DATE August 19, 1982

YZ125J ROTOR PULLER MODIFICATION

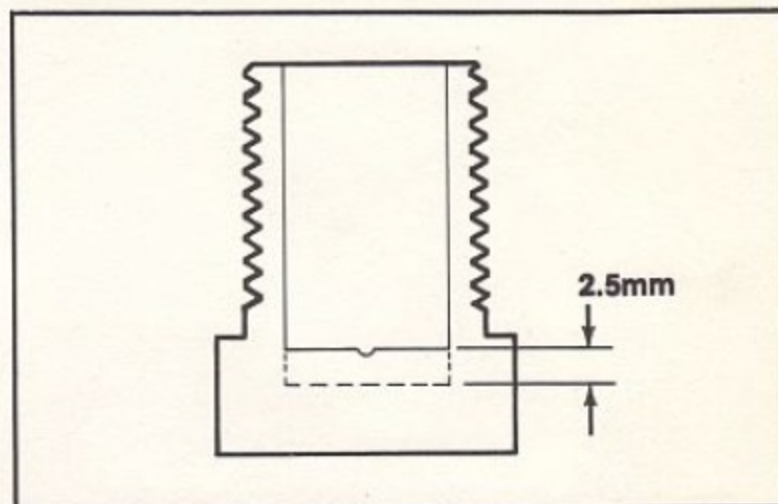
The rotor pullers for the YZ125J, including those in the owner's tool kit, do not fit properly. Because the end of the crankshaft is lengthened, the puller does not adequately engage the threads in the rotor; when the puller is tightened, threads in the rotor may be pulled out of the rotor.

To correct this problem, Kent-Moore has modified their stock of pullers. The pullers have been remachined as shown in the illustration.

Note that the bottom of the hole has been machined flat; this must be done to avoid damage to the crankshaft.
